NYC DOT's Response to Questions on Plans for West 13th Street

(Received from NYC DOT, May 11, 2026, 4:08 p.m. in response to CB2 questions 1 to 5 sent May 1, 2026, compiled after the April 28, 2026 public hearing and question 6, sent May 11, 2026.)

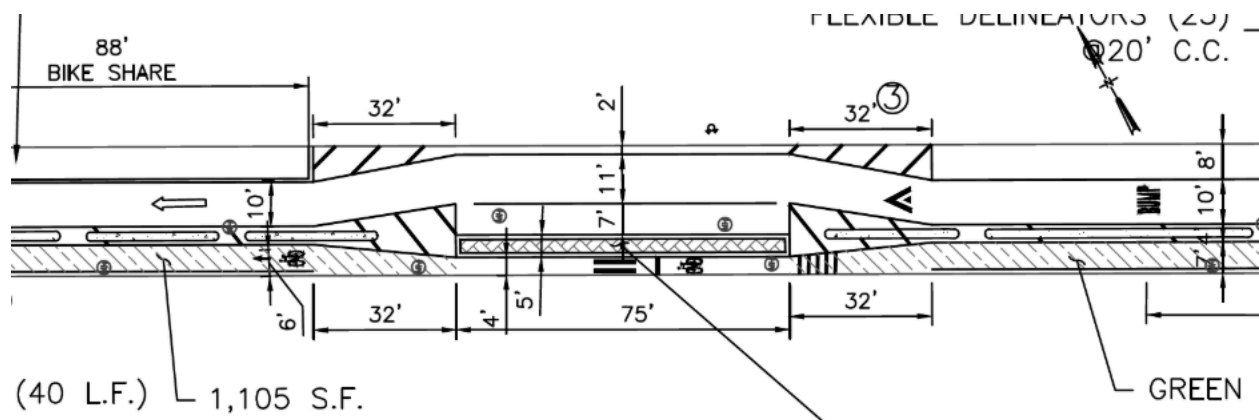
- 3. How will emergency vehicles navigate a 7 ft. wide bike lane?**

The proposed design will provide 8 ft clearance between the curb line and barrier which is wide enough to accommodate an ambulance in emergency situations with the barrier itself being low enough for a fire truck to straddle when necessary. Further design details have been provided below.
